BOLLETTINO TECNICO

N° **139-311**

**SUBFLOOR FRAME STA2105 RETROMODIFICATION P/N 3G5306P47211,
INSTALLATION OF.**

To reinforce the Tail Rotor (TR) pedals support frame, performing interim repetitive inspections until implementation of the retromodification.

Figure 6

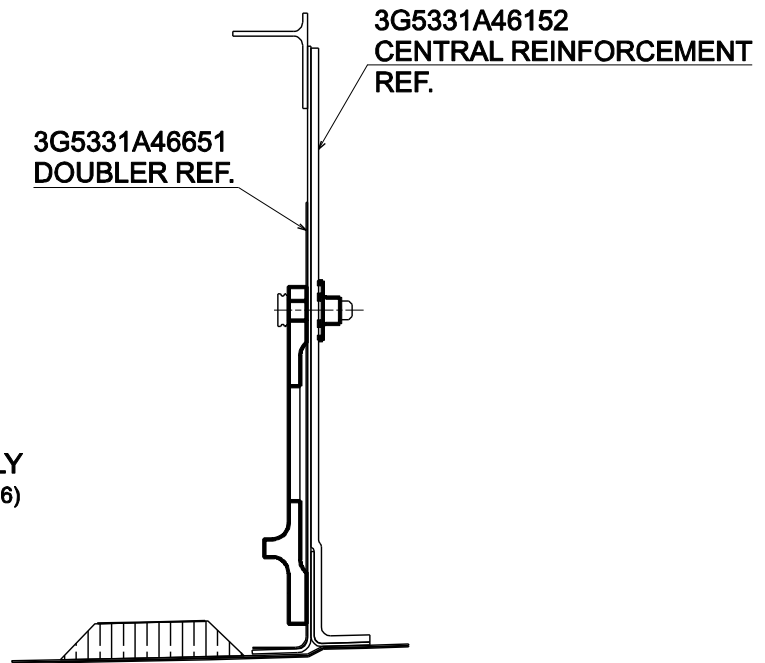
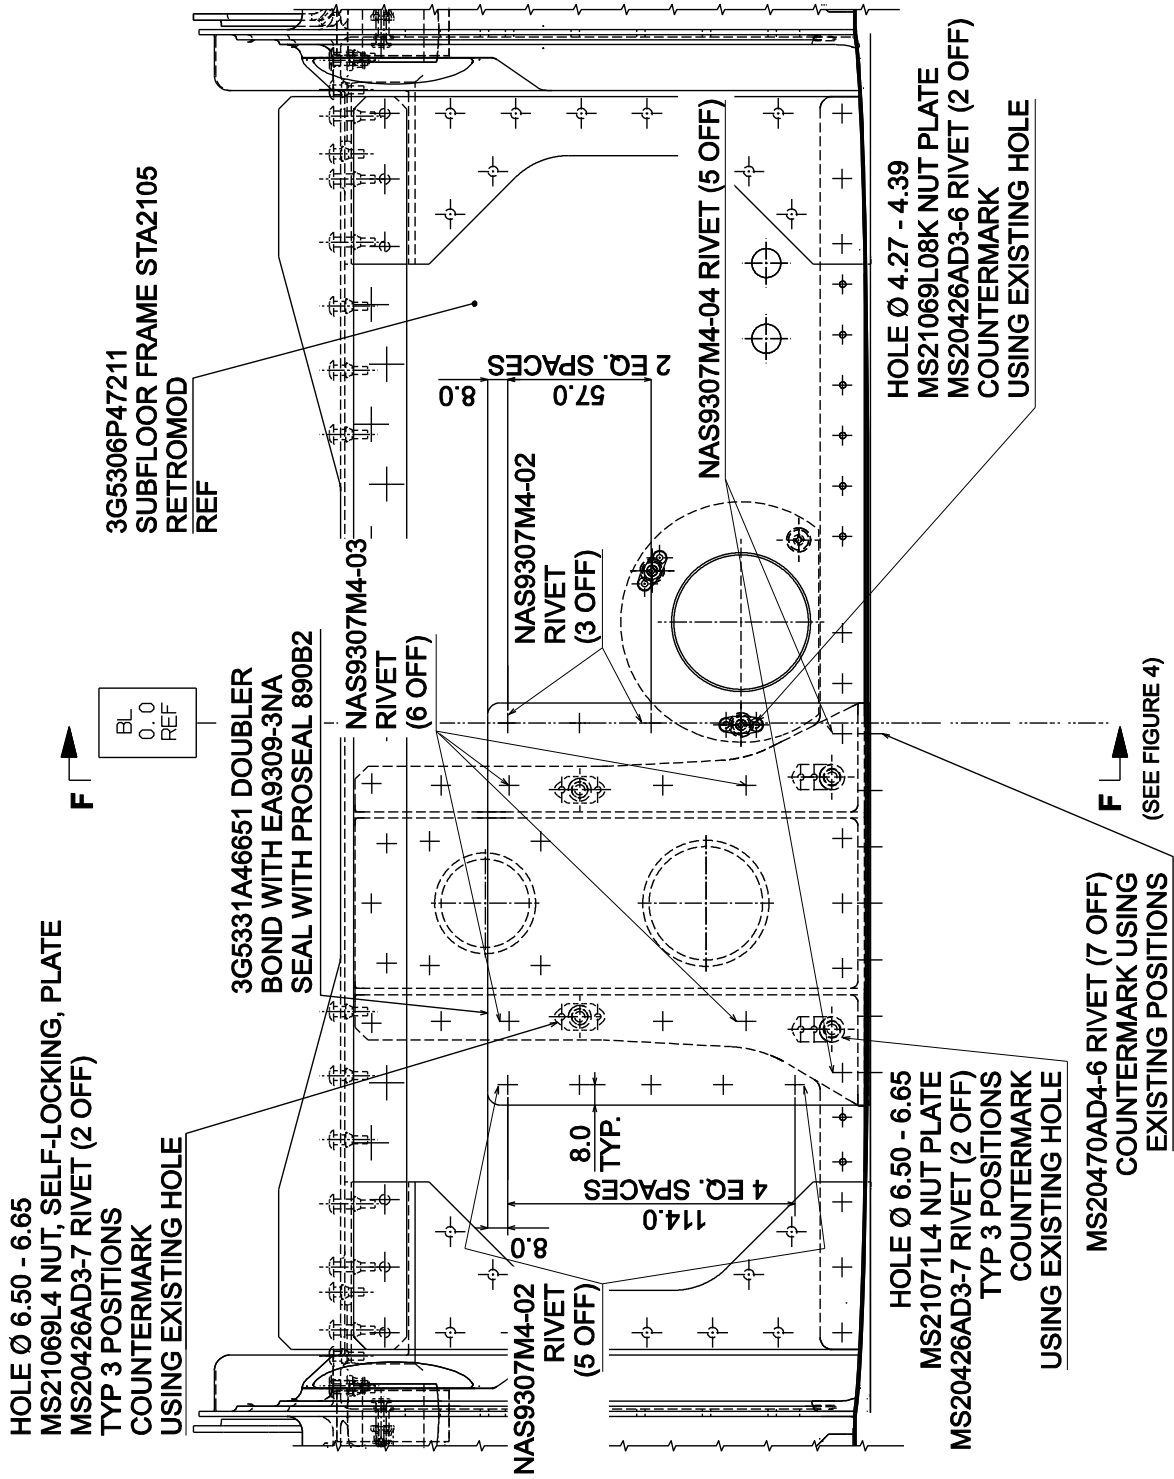
7.6.4. Put in position doubler P/N 3G5331A46651 according to figure 6 and to figure 4 section F-F and countermark holes position for self-locking nuts and rivets installation, from the middle frame on the doubler. Drill 6.50-6.65 mm diameter holes on the doubler.

instead of P/N MS20427M4-5 to fix the reinforcement on the frame and the doubler, according to figure 6.

Figure 7

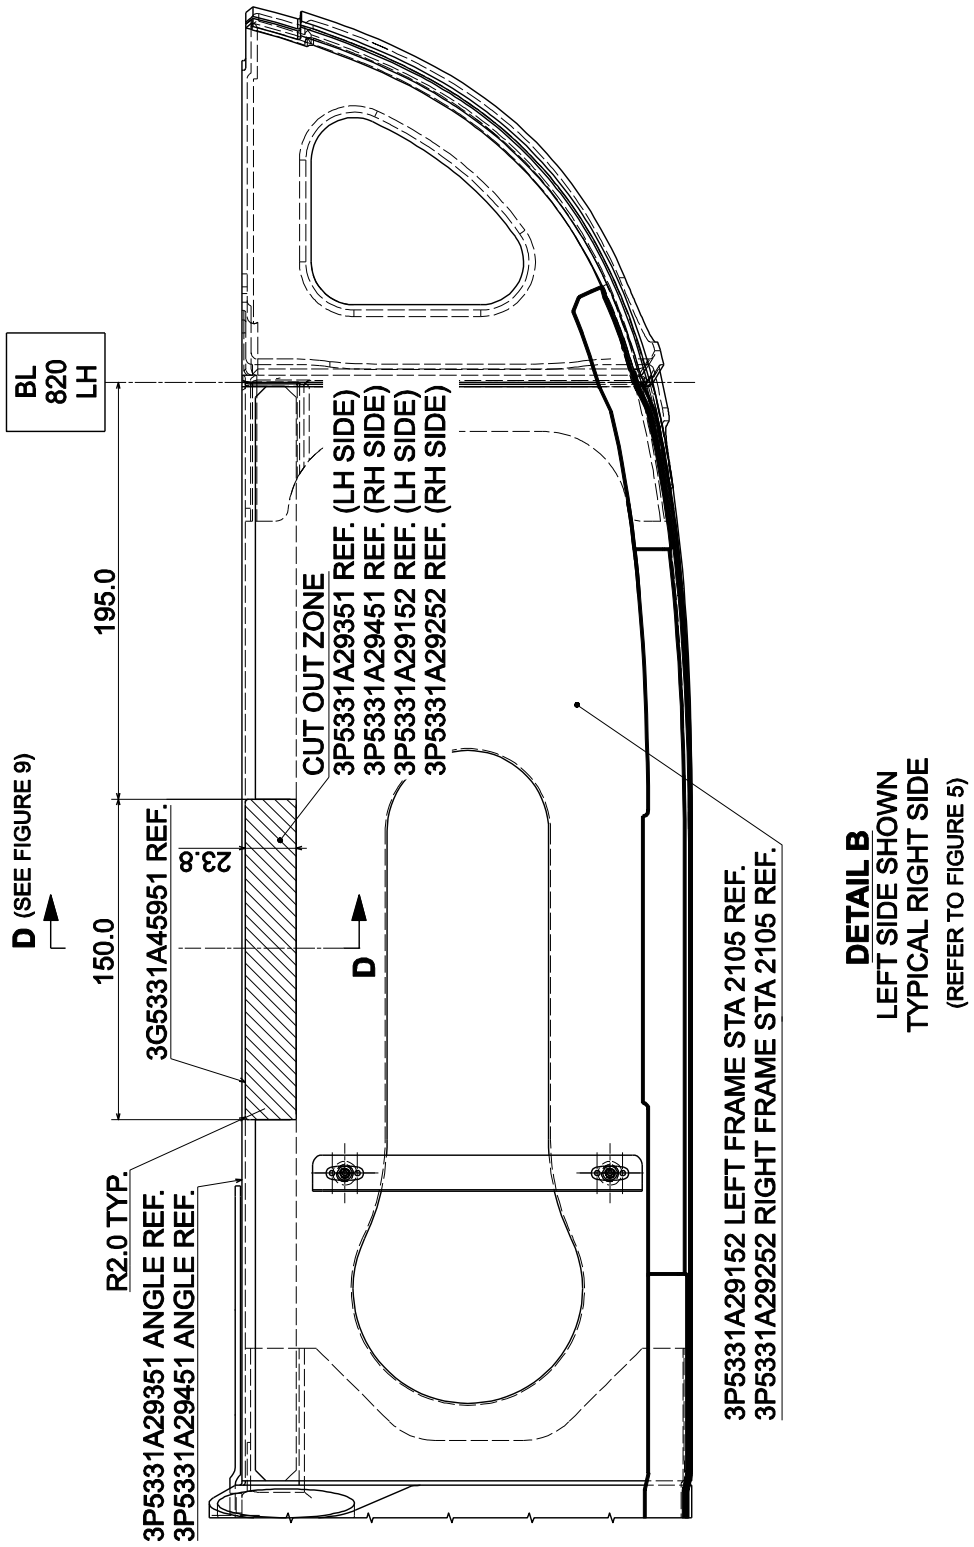
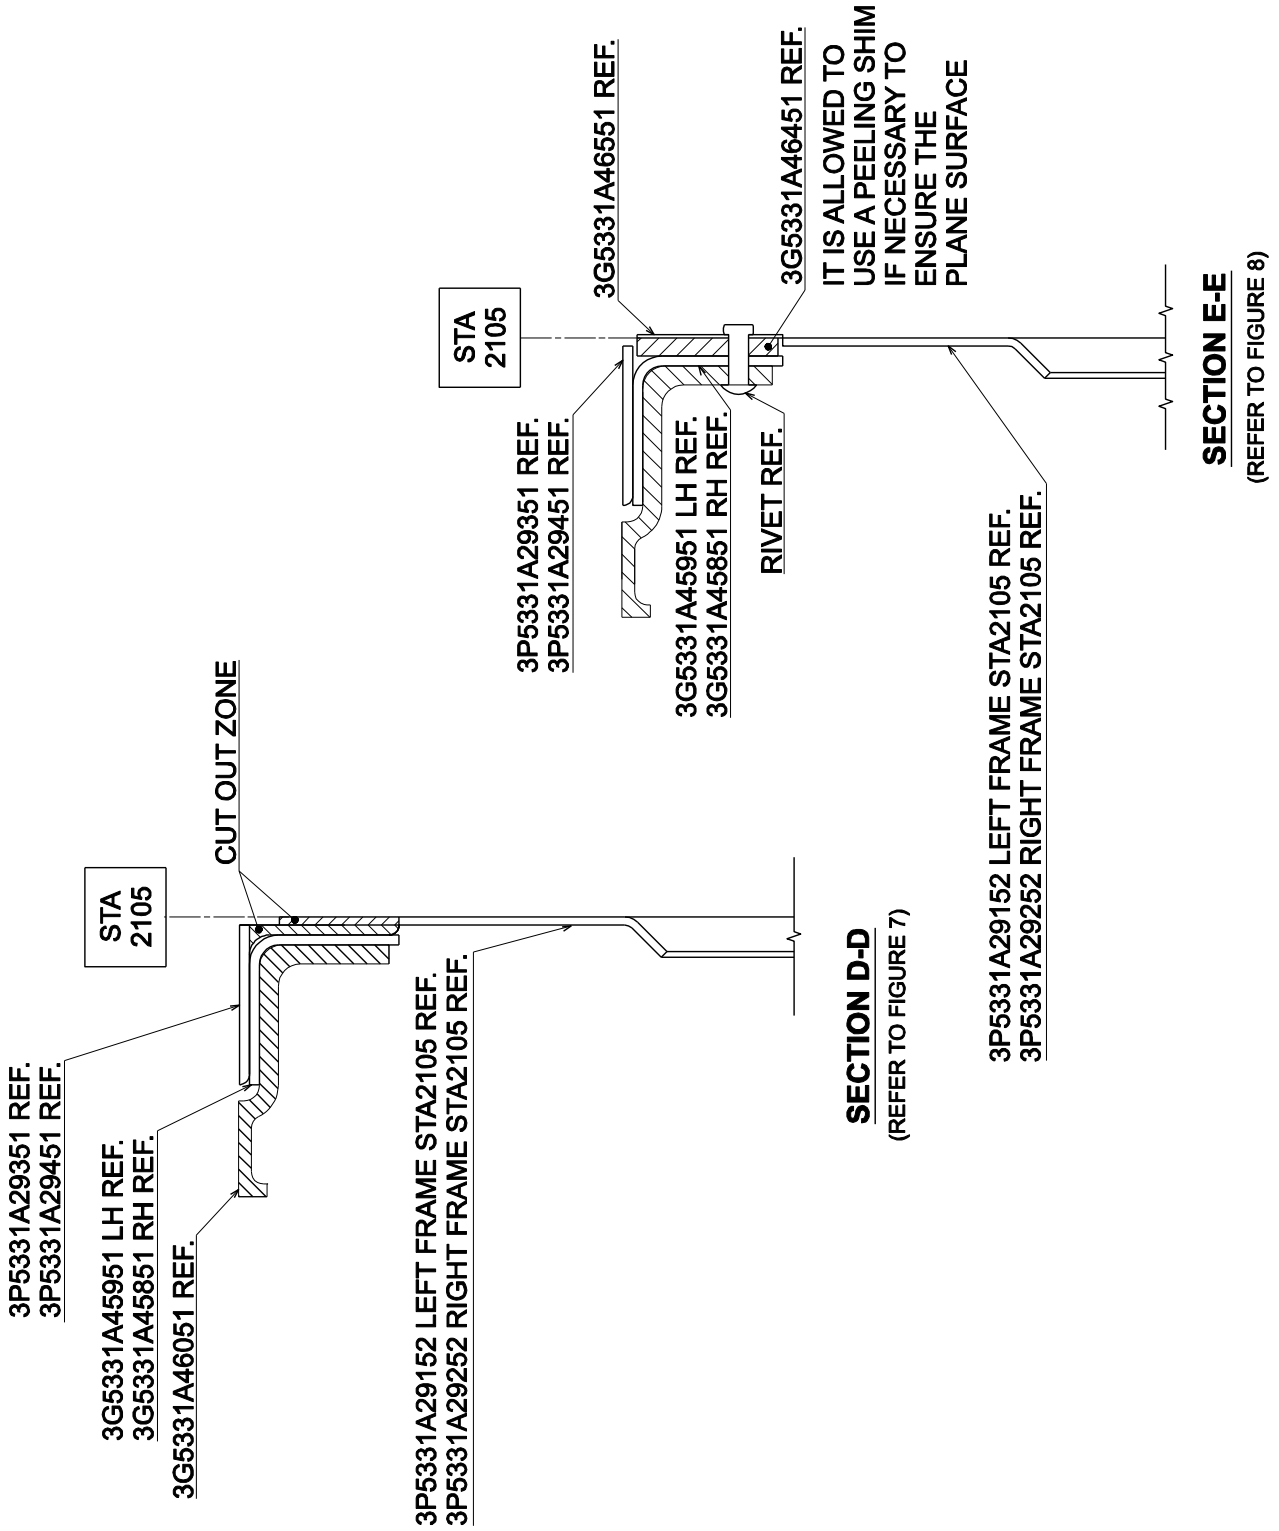
- 7.2.1. Perform cut-out of the affected area according to figure 7 and to figure 9 section D-D.

- 7.4.1. Perform cut-out of the affected area according to figure 7 and to figure 9 section D-D.

Figure 8

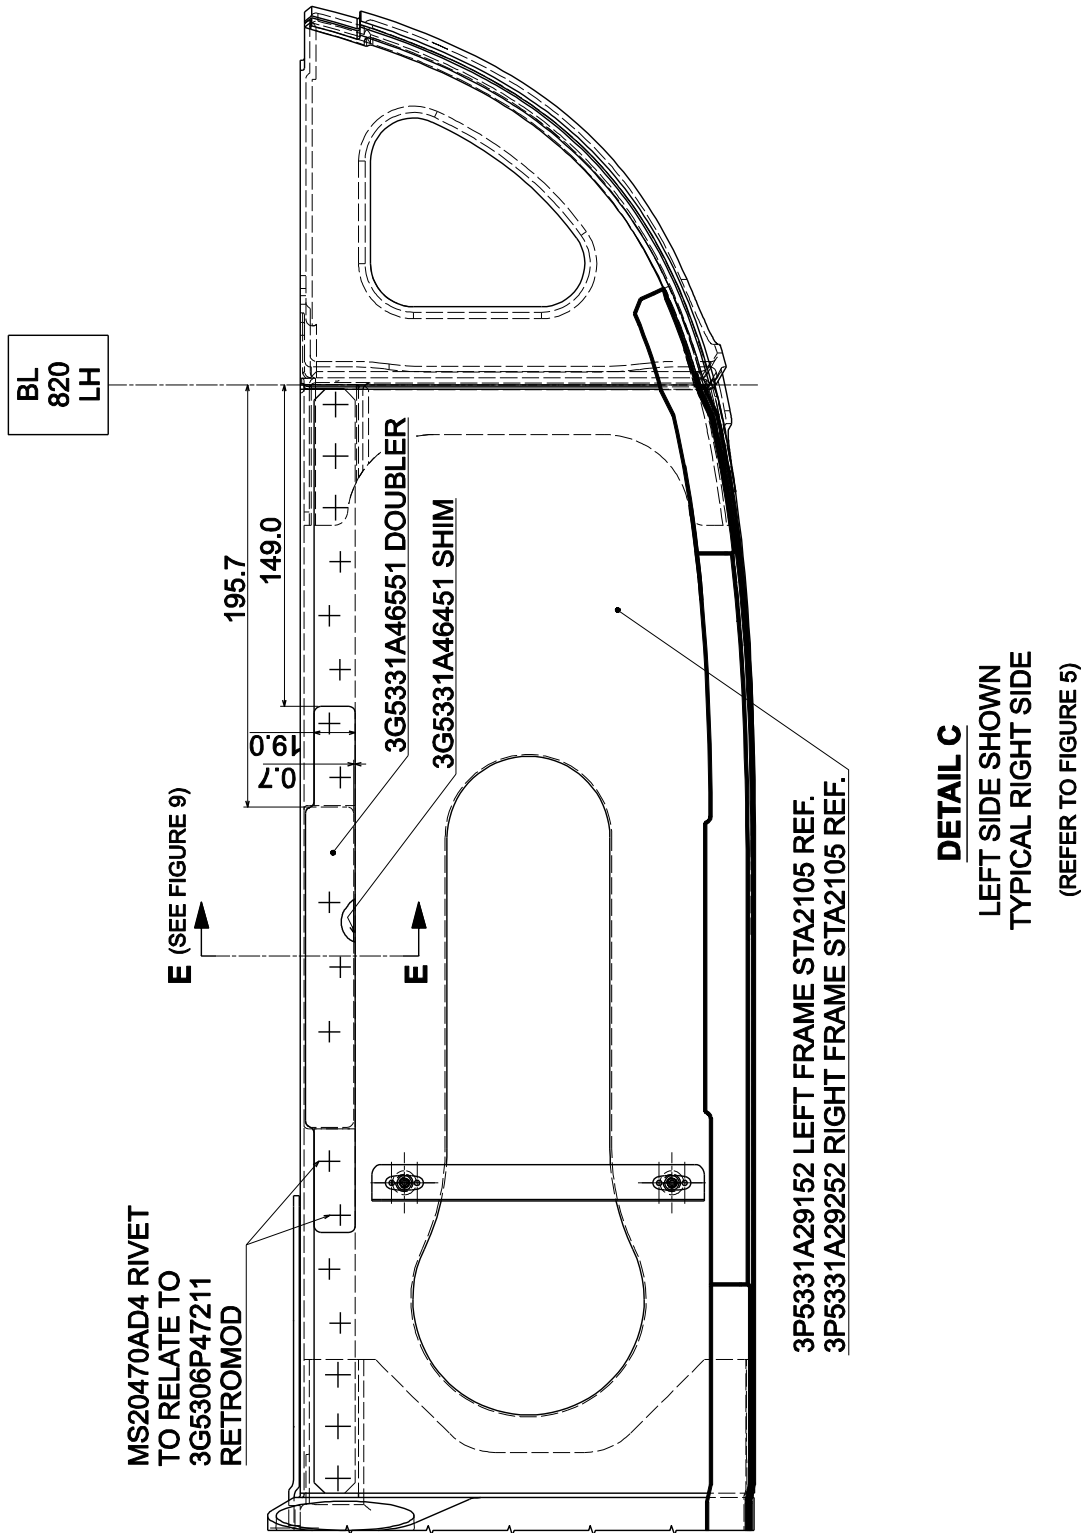
- 7.2.2. Put in position shim P/N 3G5331A46451 and doubler P/N 3G5331A46551 on RH profile P/N 3G5331A45851 according to figure 8 and to figure 9 section E-E.
- 7.2.3. Install RH profile P/N 3G5331A45851 using Proseal 890B2 (C153). Fix it to the frame (STA 2105) with rivets P/N MS20470AD4-4 and P/N NAS9301B-5-05 according to figure 12 and with rivets P/N NAS9301B-5-04, P/N NAS9301B-5-05 and P/N NAS9301B-5-06 according to figure 16.

- 7.4.2. Put in position shim P/N 3G5331A46451 and doubler P/N 3G5331A46551 on LH profile P/N 3G5331A45951 according to figure 8 and to figure 9 section E-E.
- 7.4.3. Install LH profile P/N 3G5331A45951 using Proseal 890B2 (C153). Fix it to the frame (STA 2105) with rivets P/N MS20470AD4-4 and P/N NAS9301B-5-05 according to figure 14 and with rivets P/N NAS9301B-5-04, P/N NAS9301B-5-05 and P/N NAS9301B-5-06 according to figure 16.

Figure 12

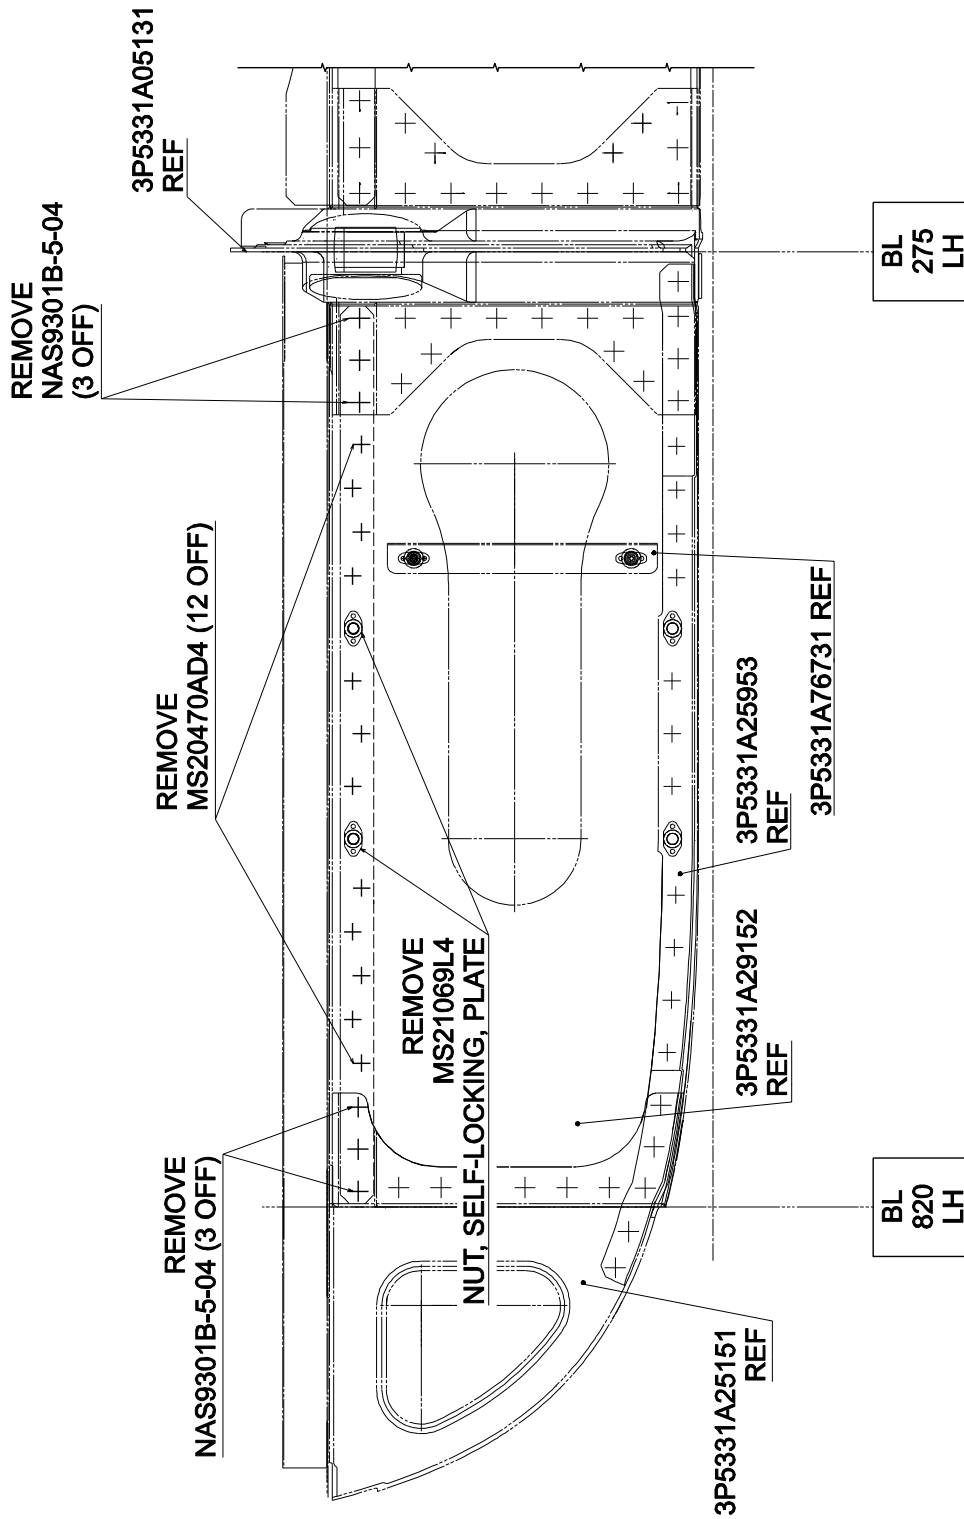
- 7.1. With reference to figure 12, remove existing rivets and self-locking nuts from RH frame in indicated positions.
- 7.2. With reference to figures 12 and 15, install reinforcements on RH frame as follows:

Performing following step 7.2.4, make sure to put reinforcement P/N 3G5331A46051 in position to drill the lateral holes at the same distance from both sides. The dimensions indicated in figure 12 are for reference only.

- 7.2.4. Install reinforcement P/N 3G5331A46051 using rivets P/N MS20470AD4-5 according to figure 12 and rivets P/N NAS9301B-4-02 according to figure 15.
 - 7.2.5. With reference to figure 12, install self-locking nuts P/N MS21069L4 according to existing holes on the structure, using rivets P/N MS20426AD3-6.
- 7.3. With reference to figure 13, remove existing rivets and self-locking nuts from LH frame in indicated positions.
 - 7.4. With reference to figures 14 and 15, install reinforcements on LH frame as follows:

Figure 19

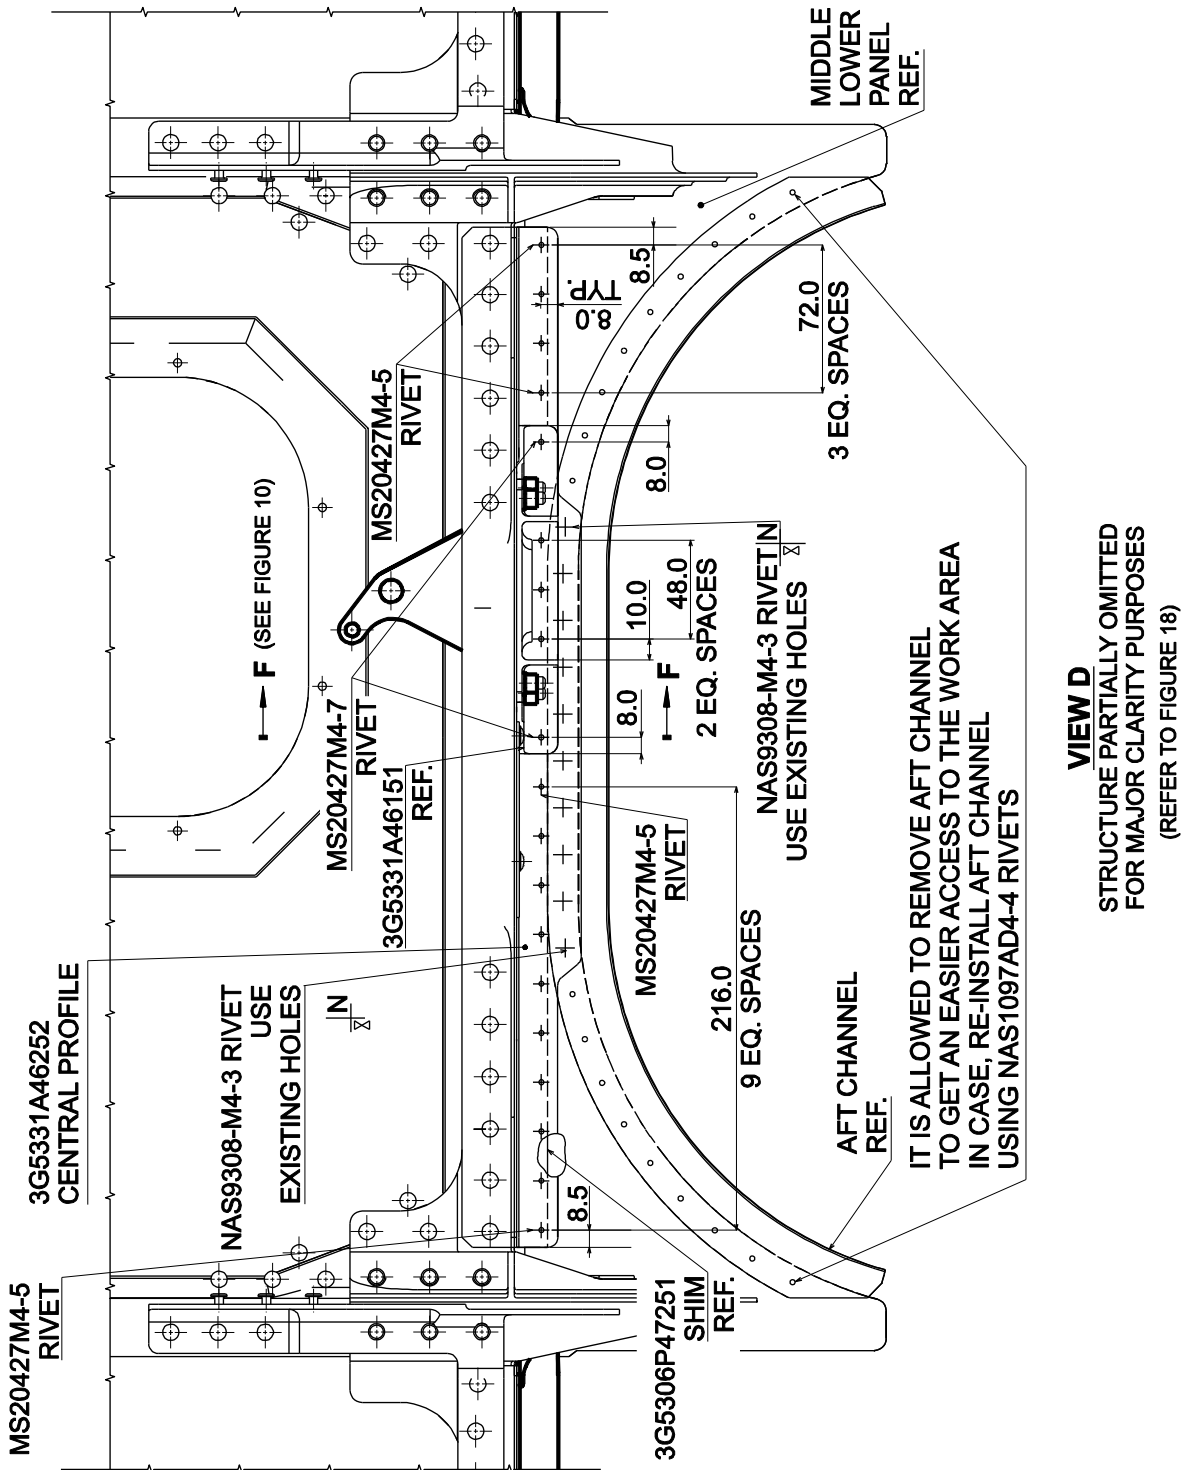
With reference to figure 19, it is also allowed to remove AFT channel to get an easier access to the work area. In this case, use rivets P/N NAS1097AD4-4 to re-install AFT channel.

7.6.5. Put in position reinforcement P/N 3G5331A46152 and central profile P/N 3G5331A46252 according to figures 18 and 19.

- 7.7.2. Install two self-locking nuts P/N MS21069L4 using rivets P/N MS20426AD3-6.
- 7.7.3. Install two self-locking nuts P/N MS21071L4 using rivets P/N MS20426AD3-6.
- 7.8. With reference to figure 19 and 21, fix central profile P/N 3G5331A46251 on the AFT channel using rivets P/N NAS9308-M-4-3 and on the middle lower panel using rivets P/N MS20427M4-5.
- 7.9. Install reworked cover P/N 3G5306P47253 on the middle frame and install removed self-locking nuts P/N MS21069L08 using rivets P/N MS20426AD3-6 according to figure 18.
- 7.10. On helicopters where doubler P/N 3G5331A46651 has been installed, install also self-locking nuts P/N MS21069L08K using two rivets P/N MS20426AD3-6, according to figure 6.
